AUTHORS' REPLIES TO RC3 SUPPLEMENT

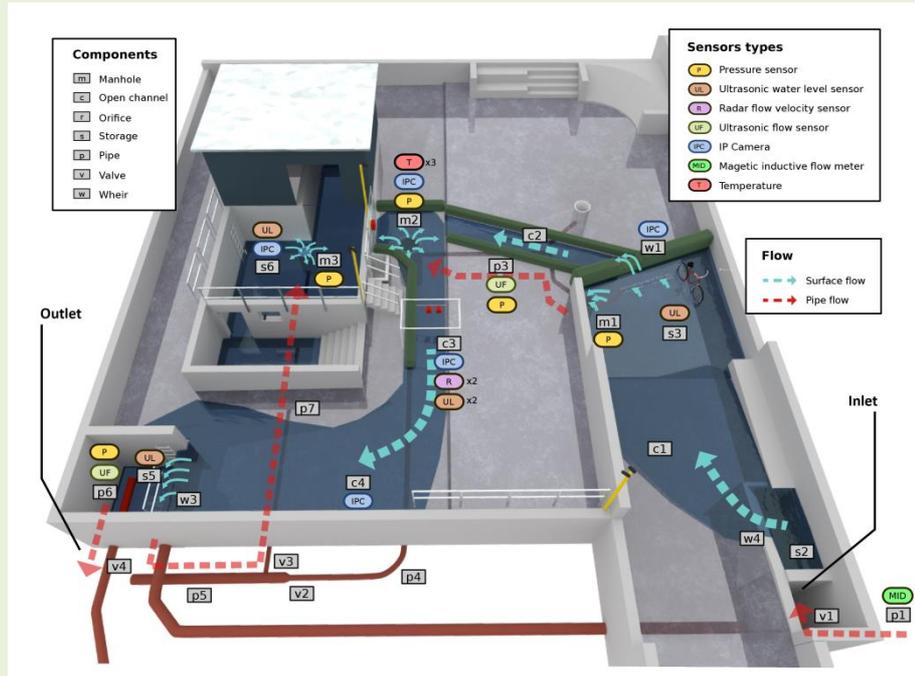
RC3.a *the experimental set up description provided in the paper is not clear and complete enough to really understand the experimental set up and the various components of the experiment. The photo provided in Figure 1 does not provide the location of the sensors and does not allow understanding how the experiment was conducted and how water was flowing. Figure 2 provides a schematic transverse view of the experiment but it gives the impression that it is only a connection of pipes and valves, and does not inform on the lateral extension of the experiment. My point of view is that the authors should provide one or more plan view of their experiment showing the interconnections between the various elements, the 2D extension of their experiment and of water flow and also the locations of the various sensors (and possibly the view angles of the cameras). The authors make reference to the floodX documentation data set that provides plans of the experimental set up, but I believe this information should be provided in the main paper, in a schematic manner, but providing information on the main elements of the experiments (reservoirs, pipes, valves, manholes, etc.), of the location of the sensors and of the main directions of the flow.*

RC3.3 *Figure 1, p.3 line 13: the figure is not clear enough and we do not see the elements mentioned by the authors. As mentioned before, one or several plan view of the experiment is necessary for the reader to understand how the experiment was working and the water flow paths. This is all the more necessary that Figure 2 gives the impression that the experiment is only a connection of reservoirs and pipes.*

Authors: We agree with the reviewer that Figure 1 did not serve its purpose of giving a good overview of the flood facility. A computer rendering of the facility was created to replace Figure 1. With such a rendering, the complete floodable area is visible.

Changes: Figure 1 has been replaced with a 3D computer rendering of the flood facility supplemented with labels indicating the most important hydraulic components and sensors. The same

symbols as for Figure 2 have been used, making the two figures easier to interpret together.

Authors: Figure 1 was indeed unhelpful and has been replaced with a 3D computer rendering of the facility and now includes the same labels as Figure 2.

Figure 2: View from camera CAM1 in which a bicycle is visible in the flood water behind the dam. Deep learning could make it possible to automatically estimate the water level from such an image. An ultrasonic sensor above the water and a pressure sensor in manhole m1 provide water level data.

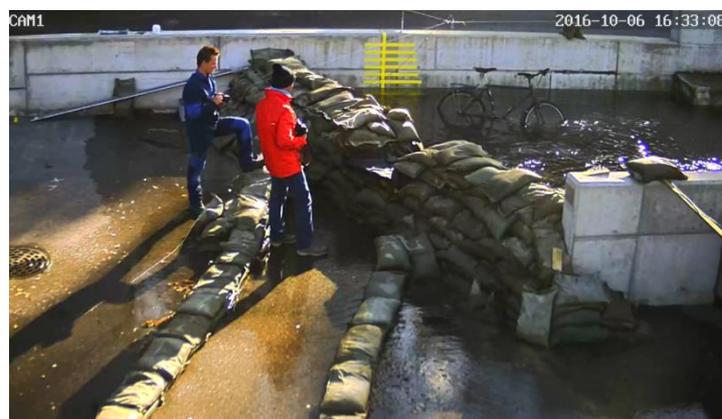
RC3.d *the authors explain with quite details, the problems they encountered with their experiments. This is a good point for the future users. However, the presentation is not balanced enough and the reader ends its reading with serious doubts about the interest of the data set. I believe the authors should also spend some times explaining what makes their data set valuable for other users, and what the strengths of their data sets are. Figure 3 is a nice summary of the collected data, but should be commented more in details to explain what can be seen in the figure. In particular the use of the temperature sensors is presented as new, but this would gain being illustrated with some examples. I also believe the OCR treatment of the data loggers is an original application that contributes to the originality of the data set.*

A trove of overland flow information lies in existing surveillance infrastructure and social media in the form of images and videos. With appropriate processing methods, flow and water depth could be automatically estimated from these data, and the floodX datasets¹ provide an opportunity to research such methods. For example, the measurement of shallow overland flows with Large Scale Particle Image Velocimetry could be investigated in channel c3 with the two cameras and two radar systems (Figure 1). For the moment, LSPIV has been investigated in urban settings only for large flows and without direct validation data (Guillén et al., 2017; Perks et al., 2016), or for seeded flows (Branisavljević and Prodanović, 2006). Another example is the use of deep learning to estimate flood water levels through semantic scene interpretation, e.g. by interpreting the immersion level of objects of known dimensions in snapshots and videos (Figure 2).

Figure 4: Measured water level in basement s6 by ultrasonic sensor s3_h_us_maxbotix presents abnormally low values after flooding (negative water levels of up to -7 mm can be seen in the red rectangle).

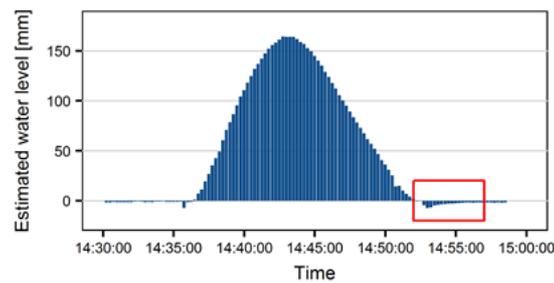
RC3.9 *Figures 4 and 5: the points the authors want to highlight are not very clear*

Changes: The Figures have been made clearer and the legends made more descriptive.
